## Appendix A

### Significant changes schedule to the Submission Plan – consultation version August 2011

### Significant changes relating to borrowpits –

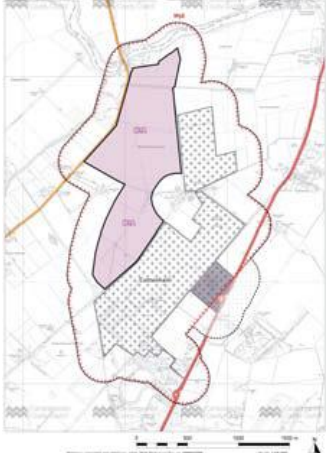
<b>Significant change relating to Cottenham site</b>			
Ref No.	Plan reference	Proposed changes by Cambridgeshire County and Peterborough City Councils	Reason for proposed change
SSP S7	Document C03, Section 7, Map for Site M1A under Heading 7.1.1 – Cottenham (M9E)	Amend map to show revised existing mineral and waste consent area & consultation area as follows:	Correction of a factual error to show new site area and consultation area
